Federal Register

[Docket No. FAA-2023-0668; Project Identifier AD-2023-00199-R; Amendment 39-22453; AD 2023-11-07]

Airworthiness Directives; Various Helicopters

ACTION: Final rule; request for comments.

Figure 1 to paragraph (g)(1)(i)—*Fundamental Effective Isotropic PSD at Outside Interface of Rotorcraft Antenna*

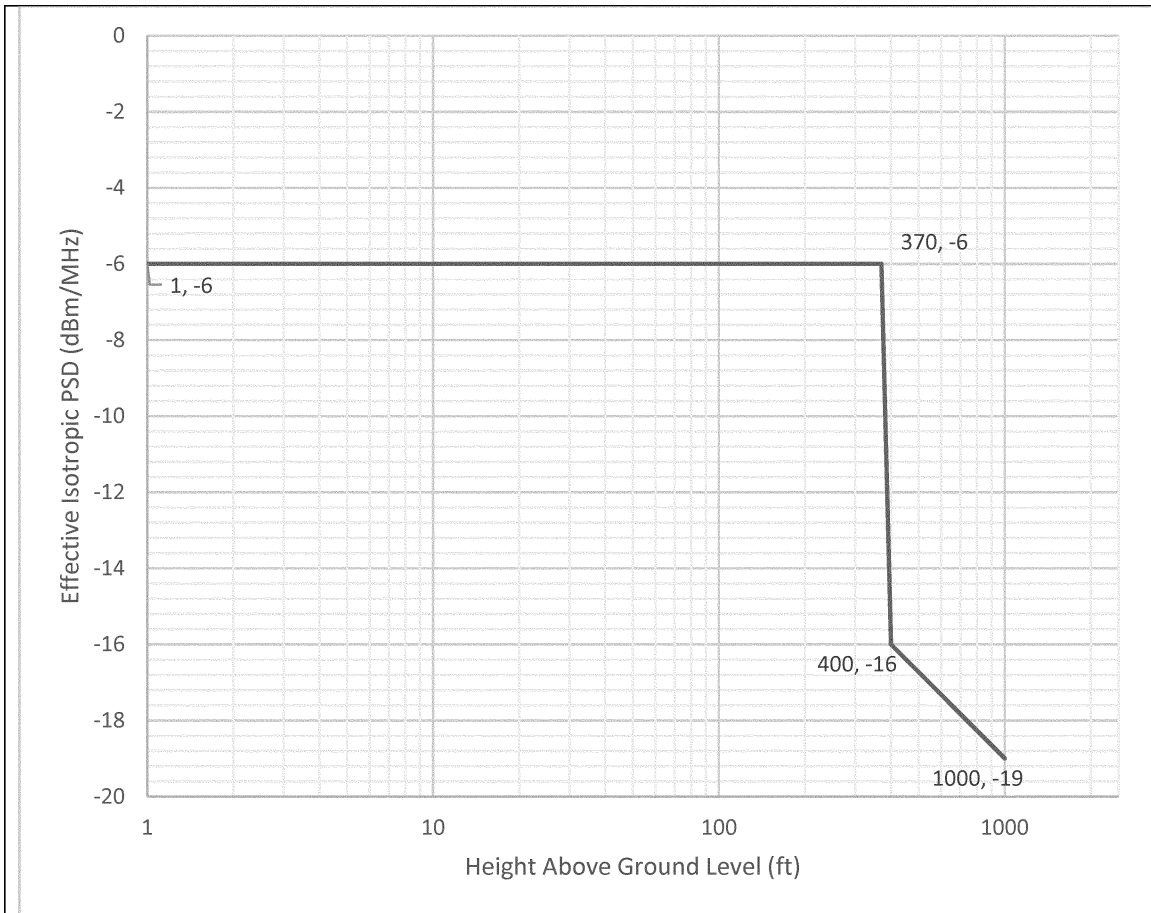
Comment summary: Thales and Sikorsky requested the FAA clarify several aspects of the PSD curve in figure 1 to paragraph (g)(1) of the proposed AD: whether no elevation mask is taken into account at and below 350 feet above ground level (AGL); at which base station emission power the PSD curve corresponds (62 dBm/MHz or 65 dBm/MHz); and whether the radio altimeter performance criteria in the curve explicitly covers any 5G emitter station up to 65dBm/MHz in the applicable 3.7–3.98 GHz band, for the foreseeable future. Sikorsky requested that the FAA revise the proposed AD to include a PSD curve that reflects the reduced EIRP levels for helicopters operating at the 188 priority airports (5G CMAs) with reduced power levels.

Comment summary: Sikorsky requested the FAA revise the PSD curve in figure 1 to paragraph (g)(1) of the proposed AD to change the height above ground at –6 dBm/MHz from 270 feet to 370 feet, and at –16 dBm/MHz from 300 feet to 400 feet. Sikorsky stated its request was based on several factors, including the minimum safe obstacle avoidance distance and the typical decision height used for radio altimeter

Sikorsky further stated that radio altimeters are not operationally used above 1000 feet, and therefore there is little value for any PSD restrictions above 1000 feet operationally.

FAA response: The notch in the PSD curve does not mean that no elevation mask is taken into account below 350 feet AGL. The elevation mask is taken into consideration below 350 feet AGL and is a fundamental consideration in how the PSD curve was established. The PSD curve was calibrated to cover 5G C-Band emitter stations up to 65 dBm/MHz in the applicable 3.7–3.98 GHz band.

The FAA disagrees with revising the AD to include a PSD curve for helicopters operating at airports with reduced power levels. The radio altimeter tolerant rotorcraft PSD curve was established to provide safe operation anywhere in the contiguous U.S. regardless of whether a helicopter is operating at a 5G CMA.

FAA response: The FAA assumed an emitter base station height of 350 feet based on consensus reached in rotorcraft industry group meetings. Additionally, FAA analysis of existing emitter base station height data shows that, while higher emitters do exist, they are infrequently adjacent to helipads. Second, the FAA assumed the rotorcraft was no closer than 50 feet above and 75 feet laterally from the emitter. The vertical distance was based on pilot feedback and the lateral distance was based on common lateral separation from the main rotor tip recommendations of 2 main rotor diameters from the tip of the rotor, selecting a 30 foot rotor as the smallest rotor in this class of aircraft with the antenna under the main rotor mast. An operator of an individual model rotorcraft with a larger rotor diameter may request approval of an AMOC to the AD on the basis of separation distance. Third, the FAA assumed that the emitter was active at the full rural power level of 65 dBm/MHz allowed in FCC Report and Order FCC 20–22.² The FAA then evaluated the resulting curve against data from radio altimeters and found it to be achievable with current technology using filters that have been developed. Based on data from existing emitters, if the height reduction from 370 feet to 270 feet, as requested by the commenter, were adopted, it would result in many more landing scenarios unprotected from interference because emitters on towers at about 250 feet as opposed to the accepted assumption of 350 feet are much more common. For this reason, the FAA did not adopt this request.

The FAA has re-evaluated the need for PSD performance requirements above 1000 feet and agrees with the reasons provided by the commenter. The PSD curves specified in this AD have been changed accordingly.

Figure 2 to paragraph (g)(1)(ii): *Spurious Effective Isotropic PSD at Outside Interface of Rotorcraft Antenna*

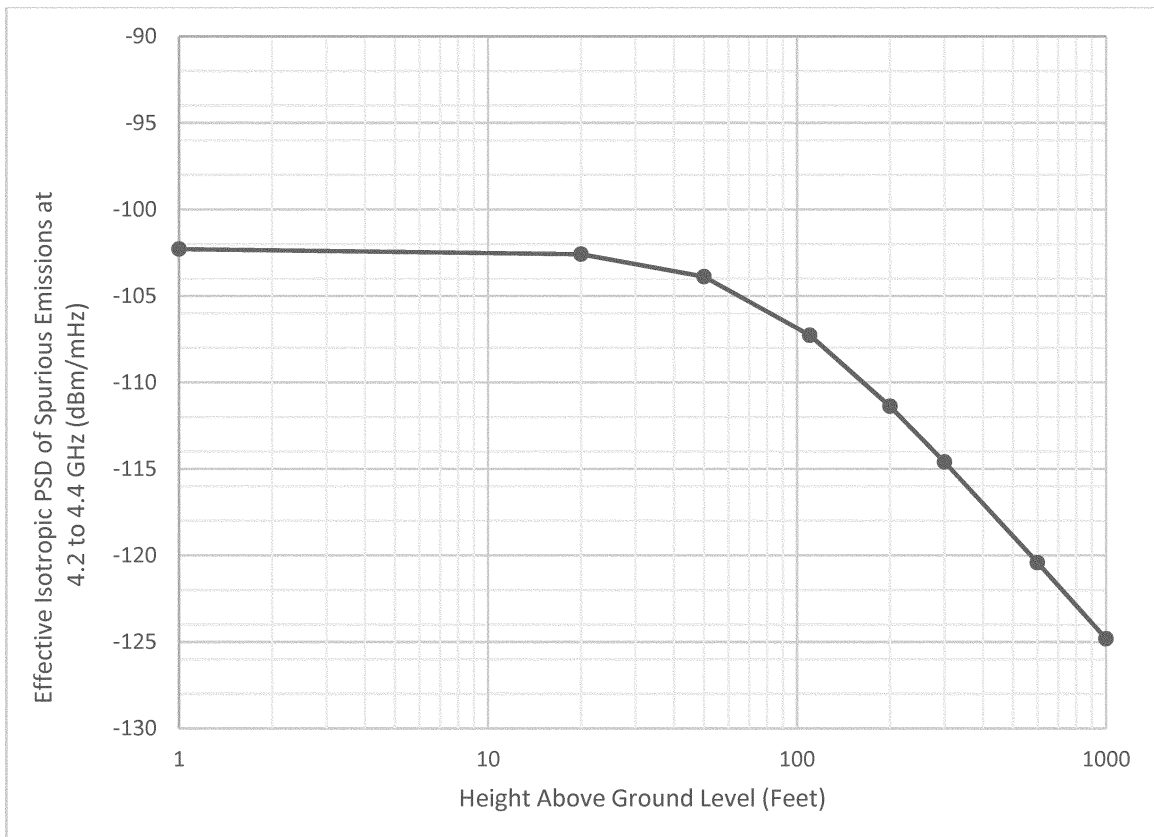
Comment summary: HAI, Sikorsky, and Thales requested that the FAA revise the proposed AD to include the frequency range to which the PSD tolerance curve thresholds apply, a new figure indicating the spurious tolerance similar to the figure with the PSD tolerance curve, and a specification of the altitude dependence for spurious tolerance.

The FAA invites you to send any written data, views, or arguments about the spurious emissions PSD tolerance curve as specified in figure 2 to paragraph (g)(1)(ii) of this final rule. Send your comments to an address listed under **ADDRESSES**. Include “Docket No. FAA–2023–0668 and Project Identifier AD–2023–00199–T” at the beginning of your comments. The most helpful comments reference a specific portion of the figure, explain the reason for any recommended change, and include supporting data. The FAA will consider all comments received by the closing date and may amend this final rule because of those comments.

In this final rule, the FAA replaced the proposed fixed aggregate spurious emission level of -42 dBm/MHz (conducted) with a spurious PSD tolerance curve for 5G C-Band interference from a single base station. This form of the requirement is consistent with the transport and commuter category airplane

requirement. Similarly, it does not include an aggregation factor or any base station or aircraft antenna gain factors. The spurious PSD tolerance curve is based on a different spurious emission level than what the FAA proposed in the NPRM (−30 dBm/MHz conducted for a single indoor base station instead of −48 dBm/MHz conducted for a single outdoor base station and an aggregation factor of 6 dB which yielded an effective aggregate level of −42 dBm/MHz).

FAA response: The FAA agrees and has added the frequency range to the PSD tolerance curve. Additionally, as explained previously under "Actions Since the NPRM Was Issued," the FAA has replaced the proposed fixed emission level with a spurious PSD tolerance curve.
